Notice of Decision

Land Division (Tentative Partition Plat), and Floodplain Review

PA-04-23 & FP-04-23

November 20, 2023

TENTATIVE PARTITION PLAT
FOR
GARALDINE MARTIN
LOCATED IN
ALEXANDER M. RAINWATER D.L.C. No. 39
SE 1/4 SEC. 1, T. 11 S., R. 4 W., W.M.
IN THE
CITY OF ALBANY, BENTON COUNTY, OREGON
JULY 26, 2023

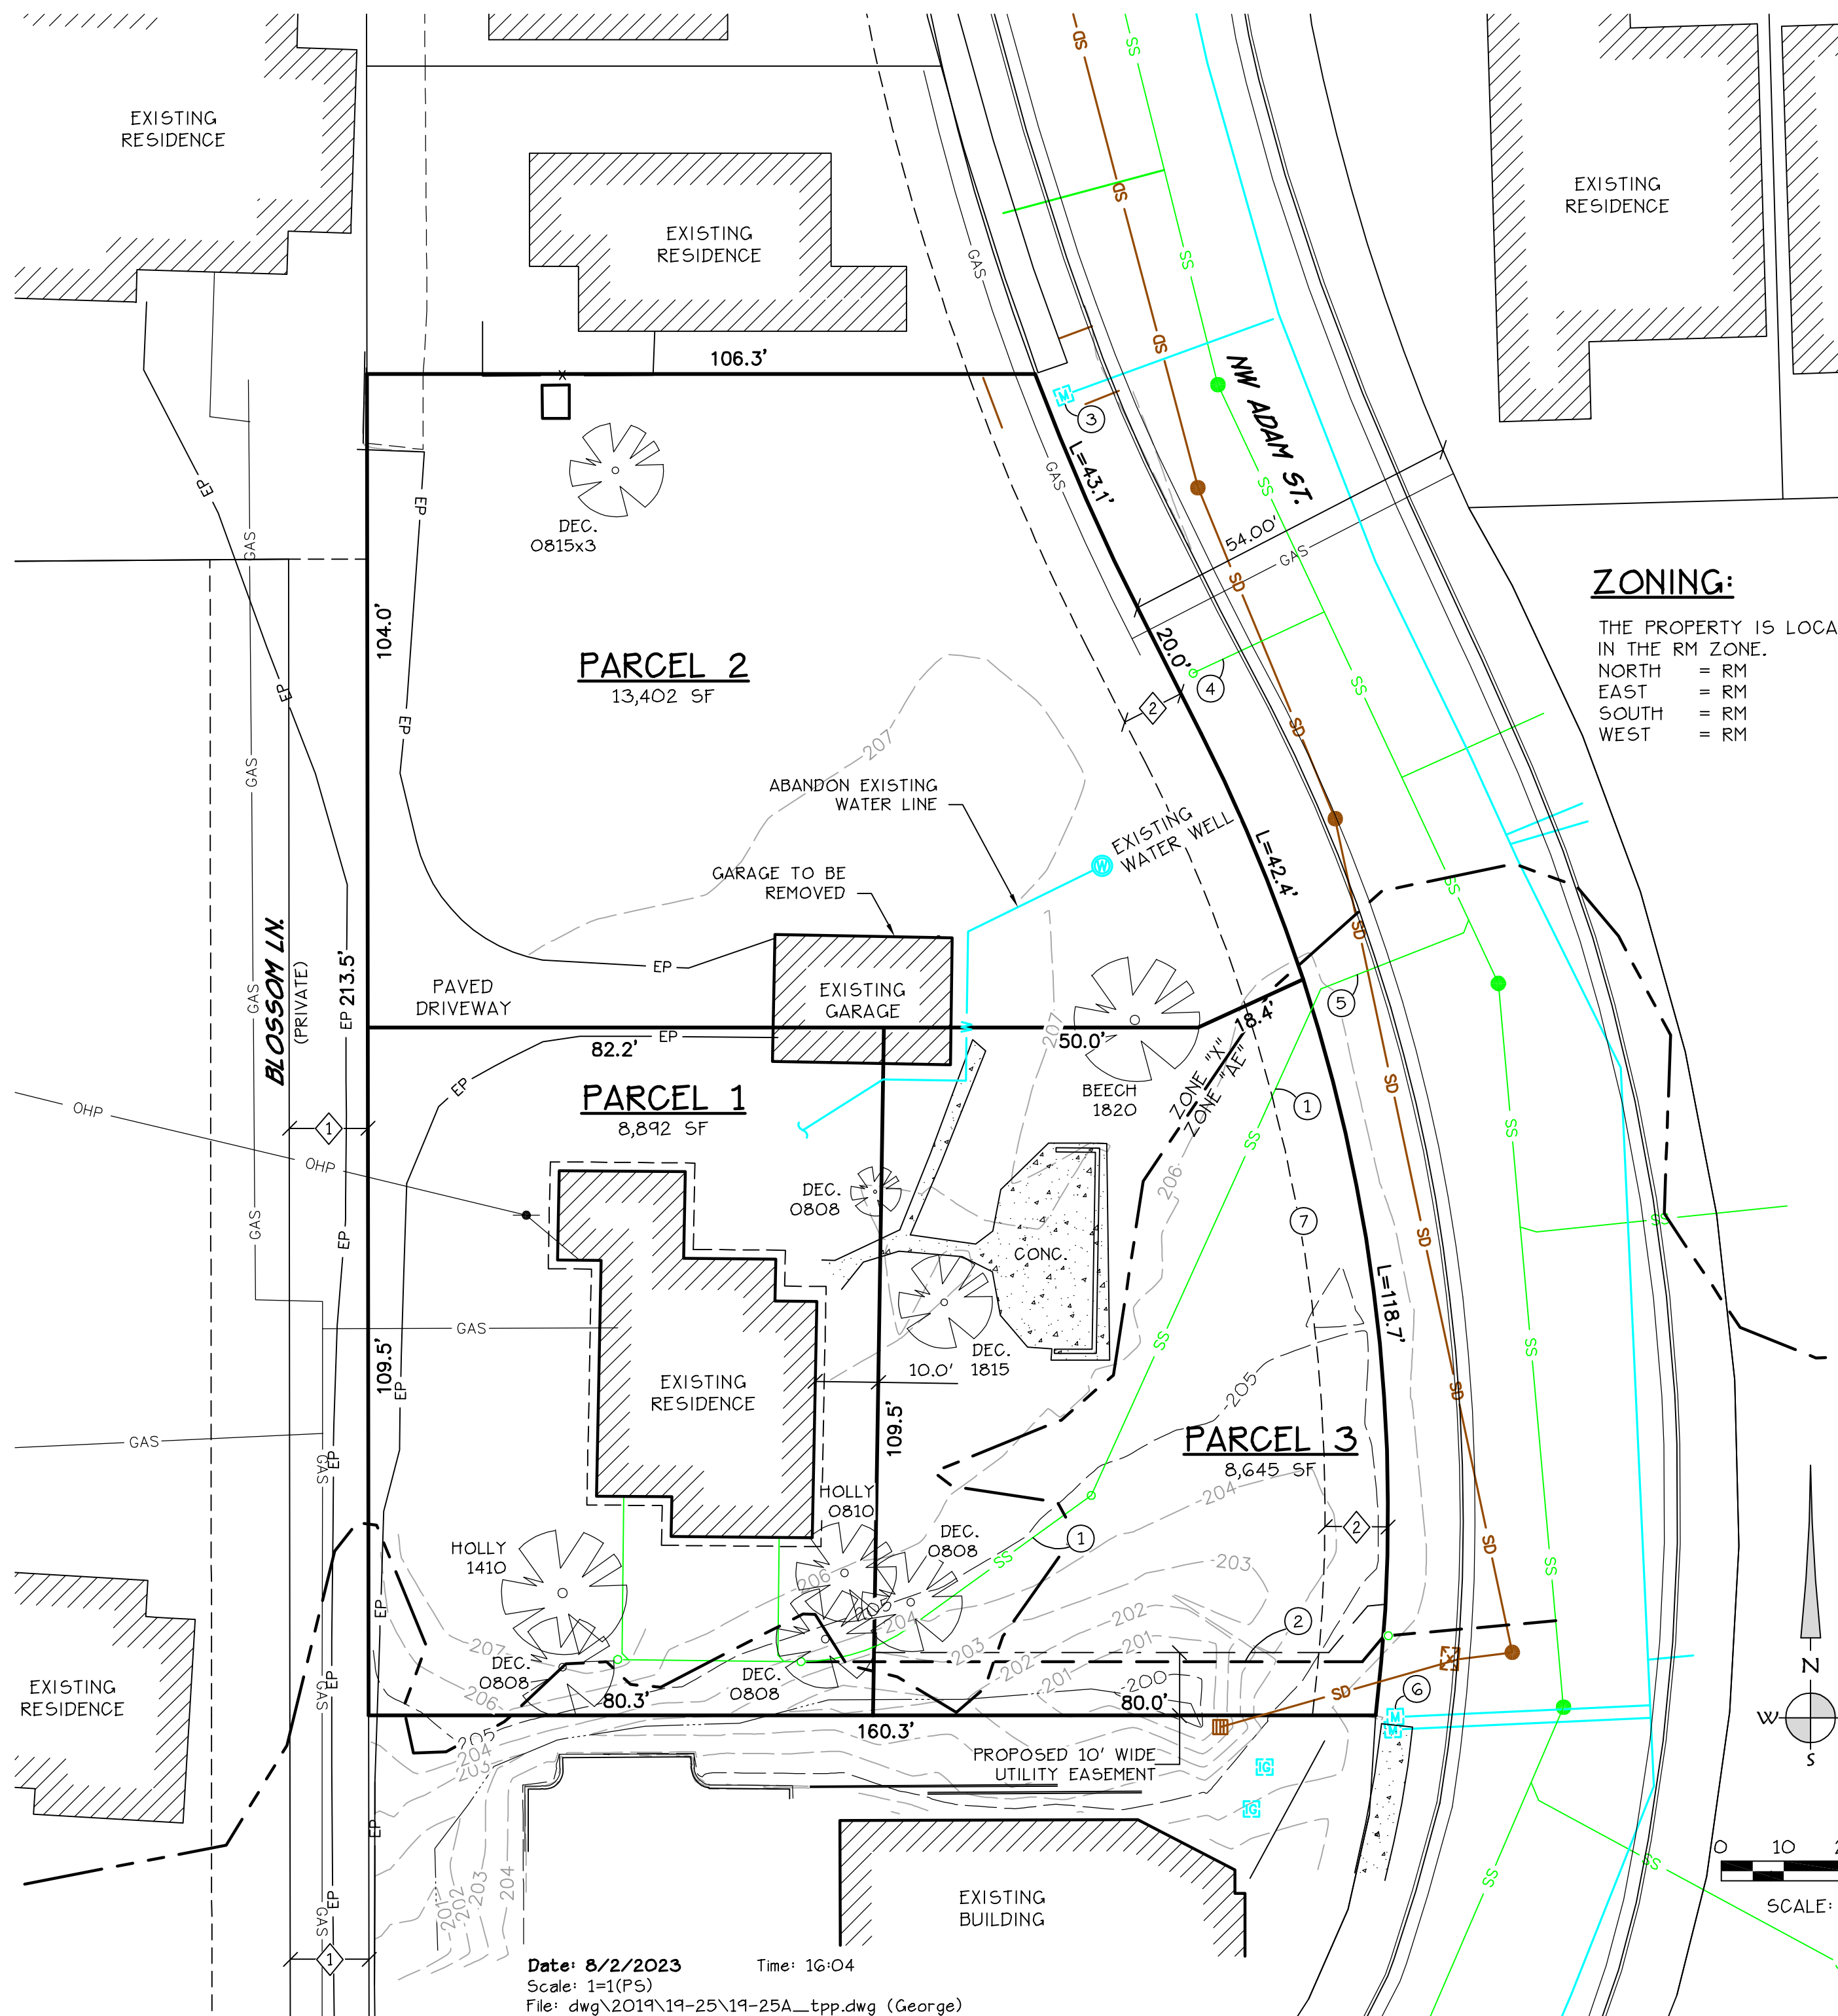
- Condition 1** Prior to the signing of the final plat, the property owner shall obtain and finalize a demolition permit for the existing accessory structure.

- Condition 2** Before the applicant can make a new sewer service connection to the public sewer system an Encroachment Permit must be obtained from the Public Works Department.

- Condition 3** Before the City approves the final partition plat, the applicant must pay all connection charges associated with existing public water and storm infrastructure in Adam Street along the frontage of the subject property.

- Condition 6** The final plat must include a statement that reads as follows: **“Development of property within the Special Flood Hazard Area as most currently established by the Federal Emergency Management Agency or City of Albany may be restricted and subject to special regulations by the City.”**

Blossom Lane does not meet this condition.

An approved turnaround will be required if access is taken from Blossom Lane.
